**NSLPP MEETING HELD ON 04/06/2025****Attachments:**

**ADDRESS/WARD:** 18 Larkin Street, Waverton (W)

**APPLICATION No:** DA61/25

**PROPOSAL:** Alterations and additions to the existing dwelling including sub floor excavation and installation of a lift

**Figure 7:** Proposed height 10.8 measured from existing Lower Ground Level RL27.14 (Extract from proposed Section C-C)

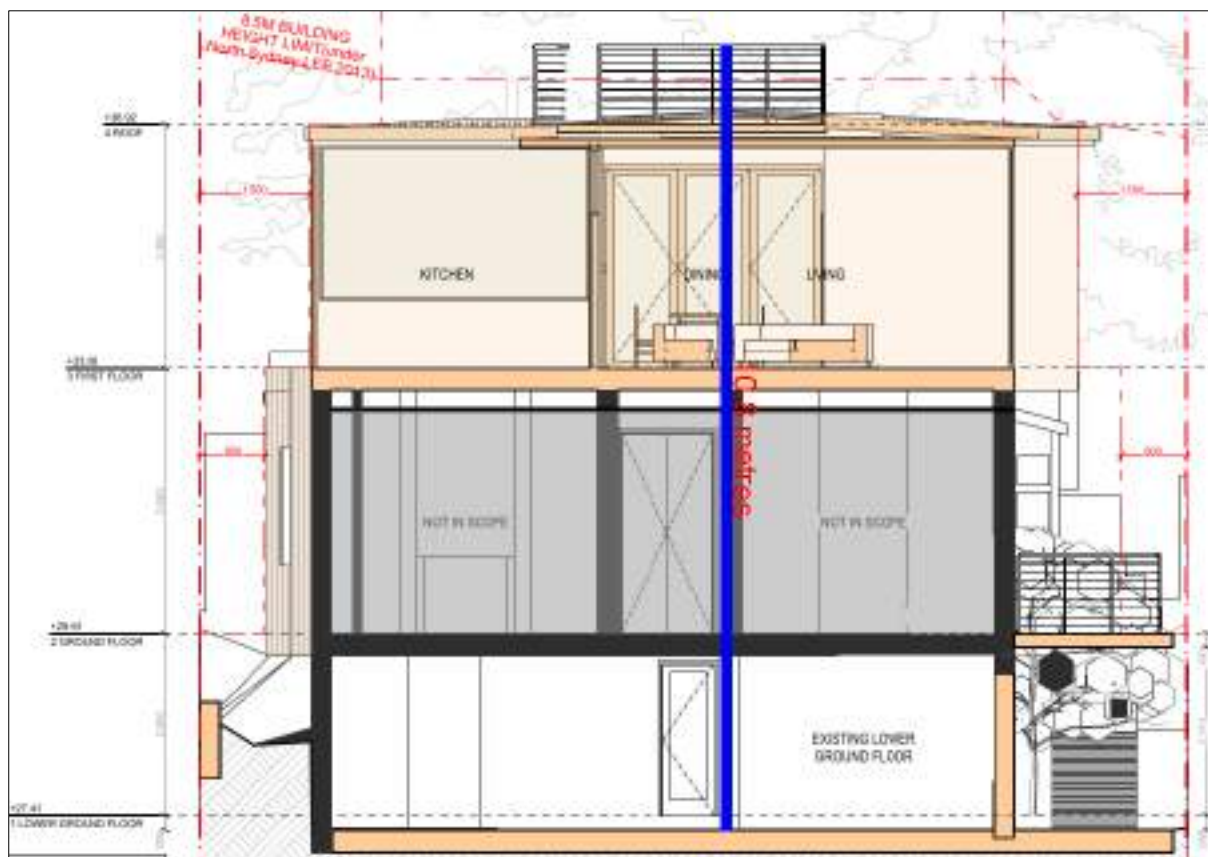
The proposed works would have a height of 10.8m measured from the existing Lower Ground Level (RL27.14 Existing Garage Level based on survey plan) to the roof balustrades that does not comply with the permissible height limit of 8.5m in accordance with clause 4.3 in *NSLEP 2013*.
